**Addendum #1**  
**2020 Roadway Improvement Project**  
**“Cambridge Drive Neighborhood”**  
**Bid No. 20-15**  
**Town of East Hartford**

**February 28, 2020**

The following summarizes the revisions to the Bid Documents included in Addendum #1 for the 2020 Roadway Improvement Project (Bid No. 20-15).

PROJECT NO.:  
**42413.00**  
DRAWING NO.:  
**MDS-03**  
SHEET NO.:  
**007 OF 294**

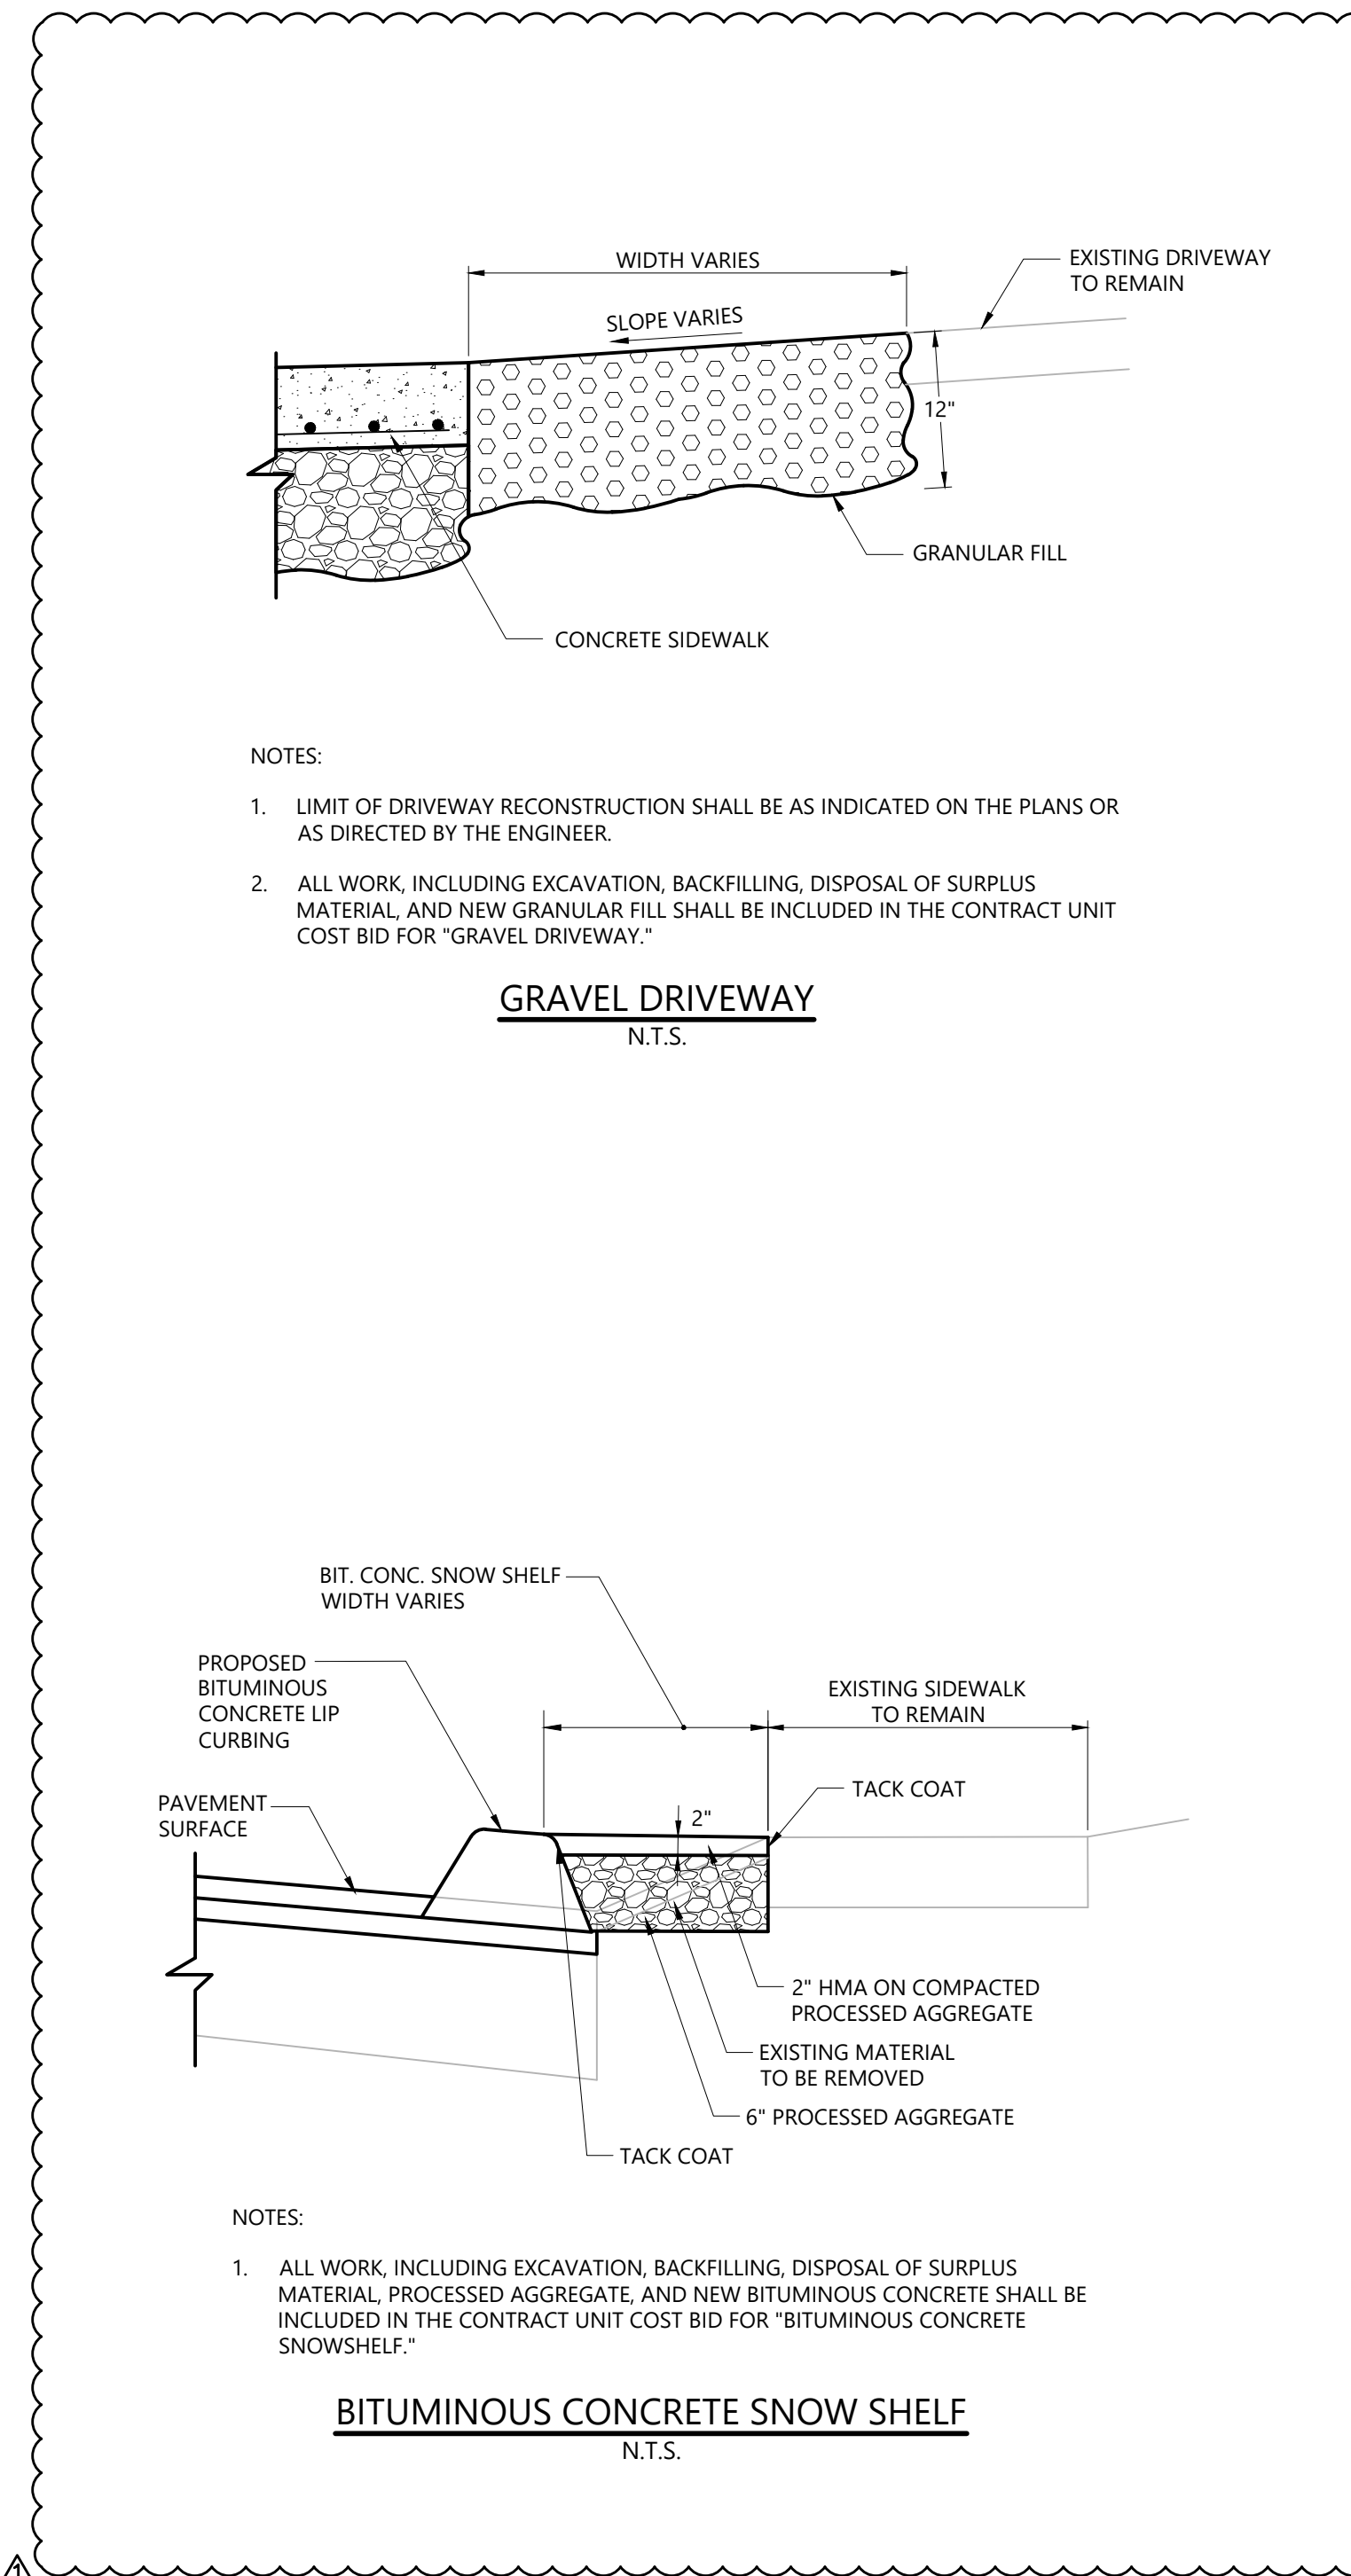
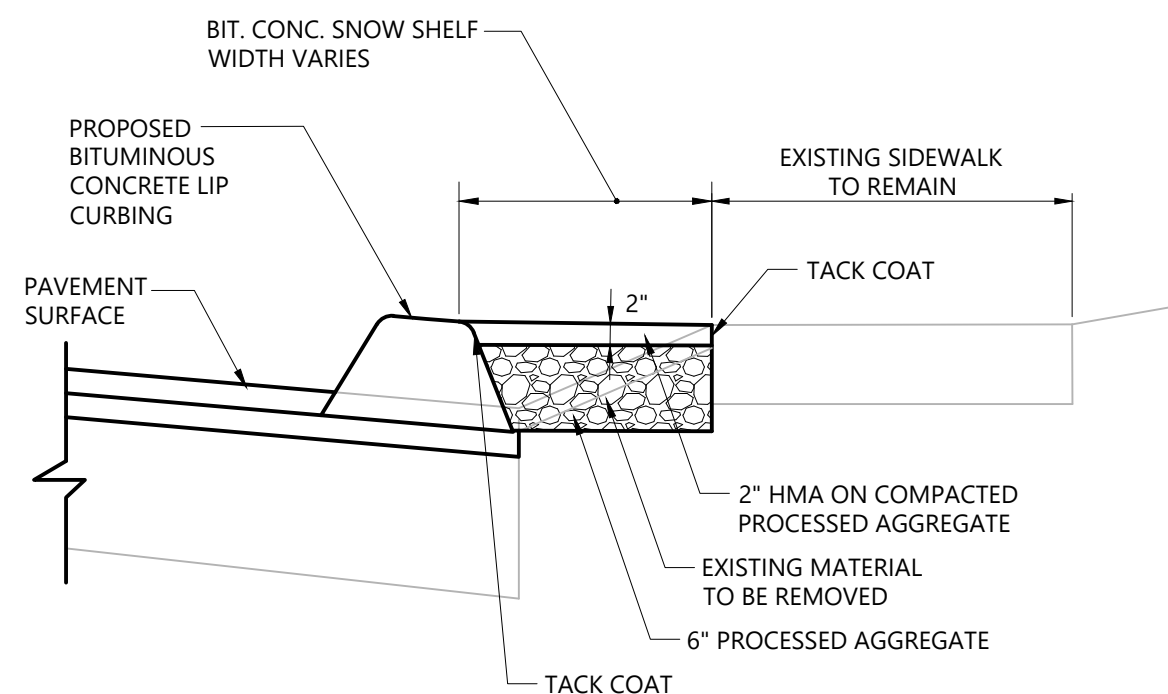
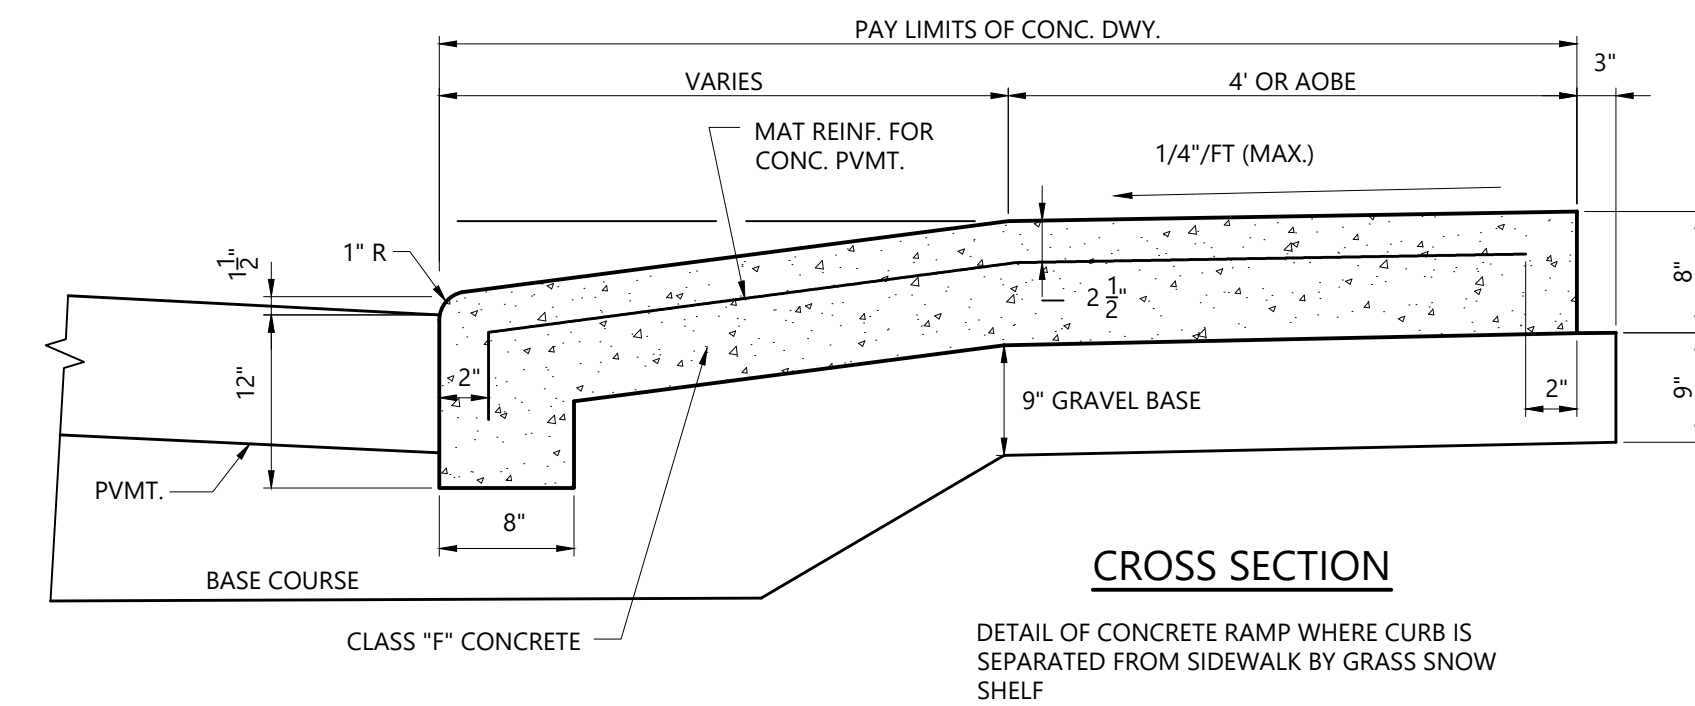
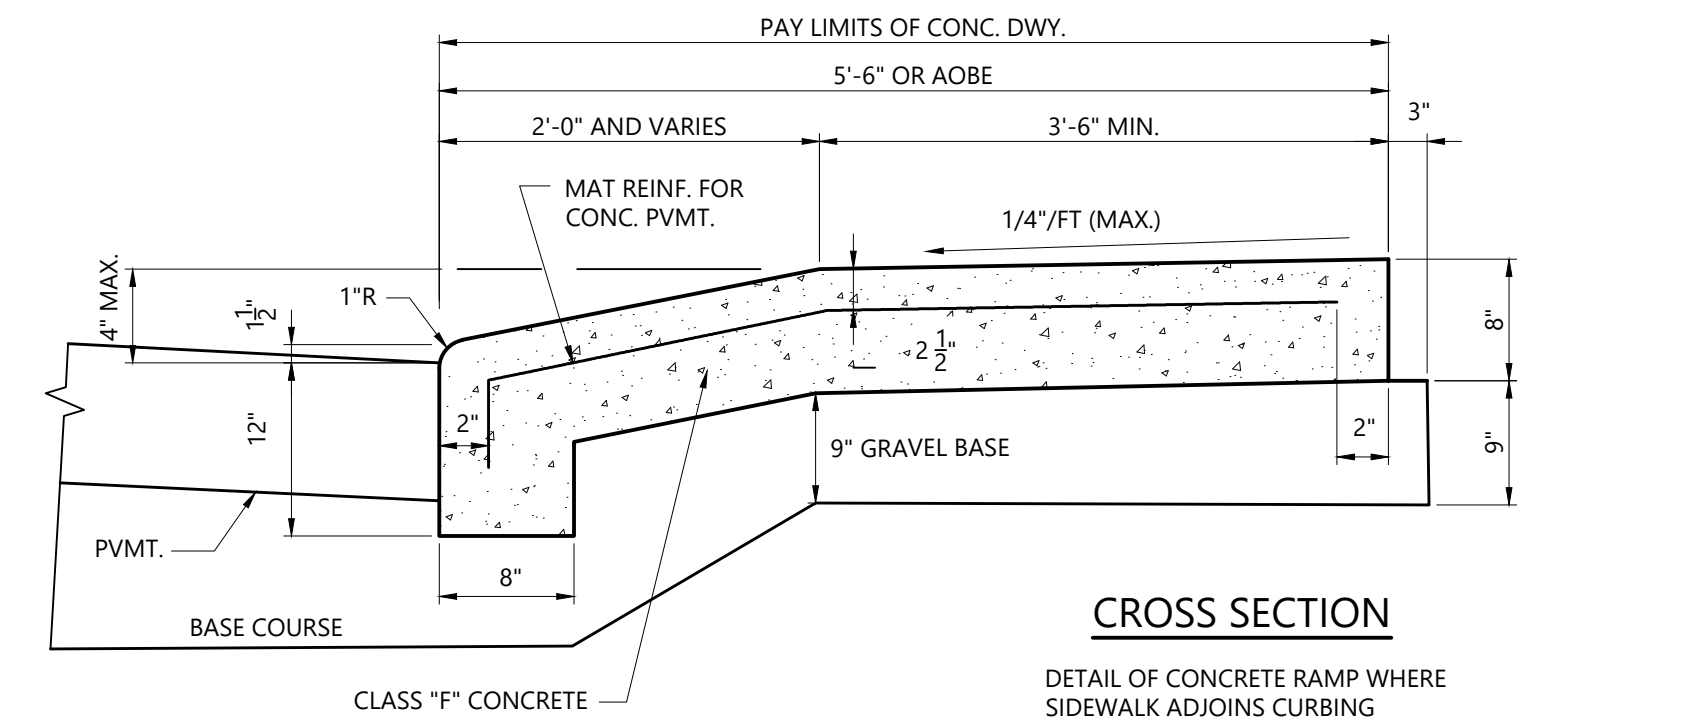
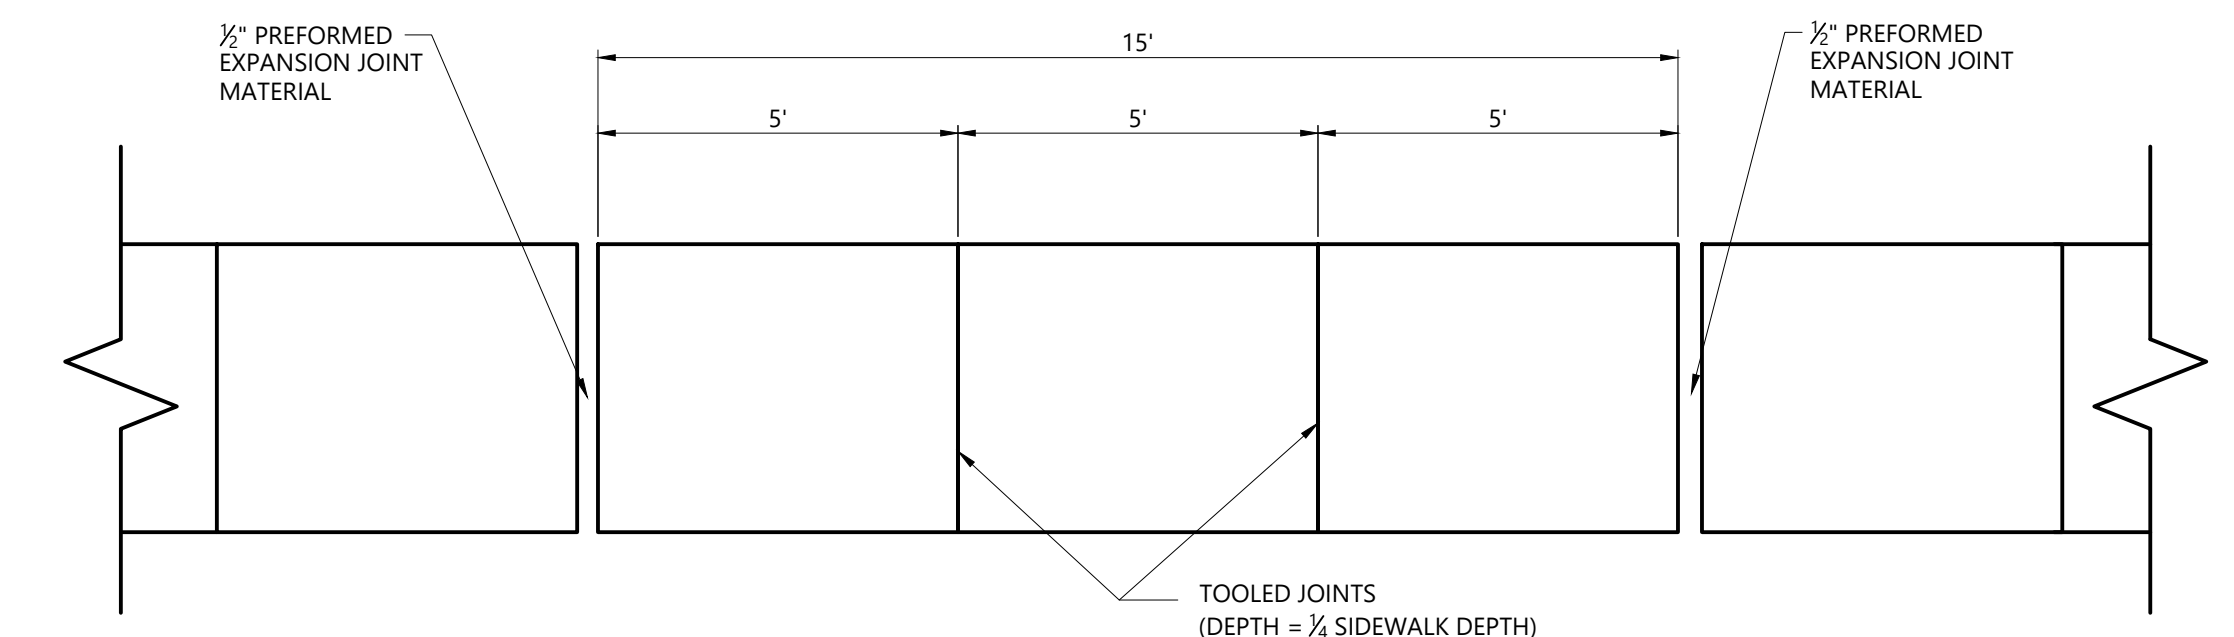
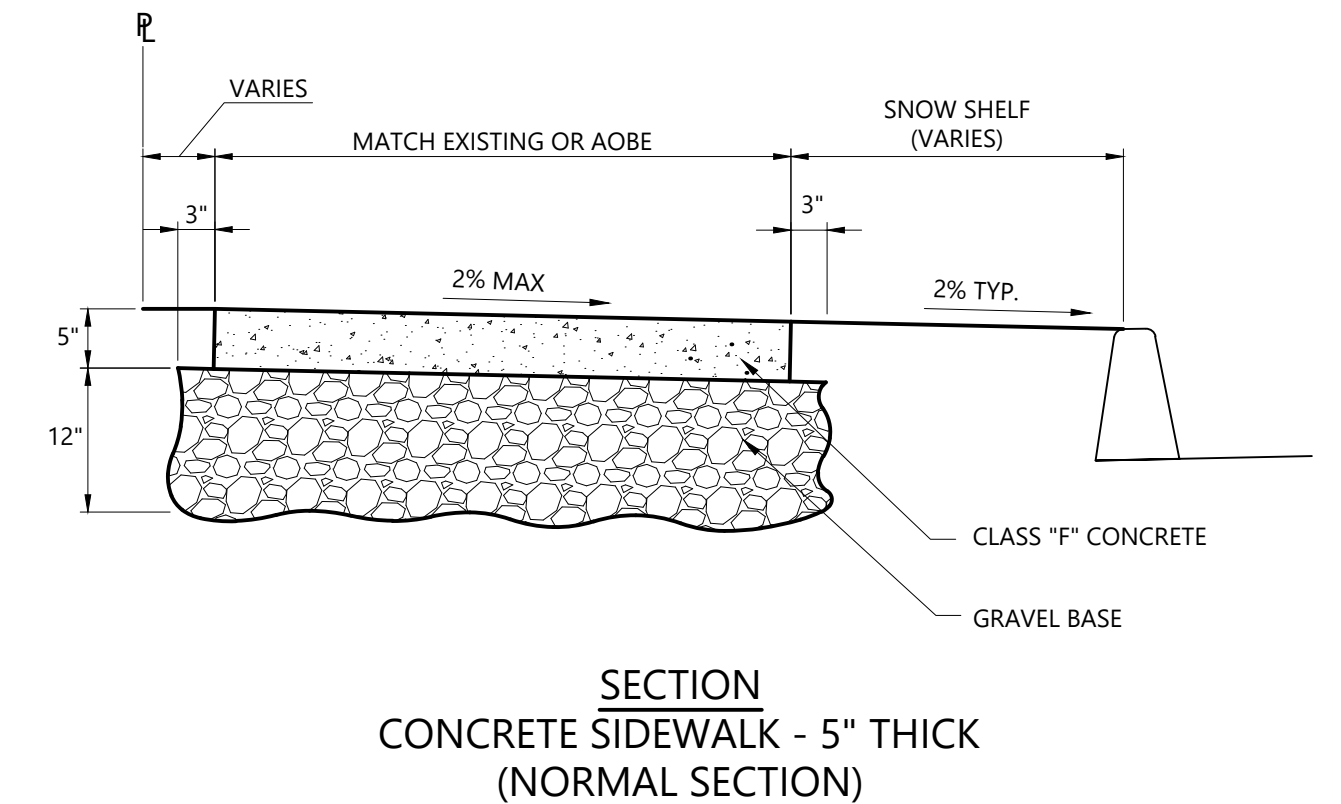
- Replace plan sheet 007 of 294 to reflect the addition of Gravel Driveway and Bituminous Concrete Snow Shelf details.

REV.	DATE	DESCRIPTION	SHEET NO.
02/25/20	ADDED CONSTRUCTION DETAILS		007
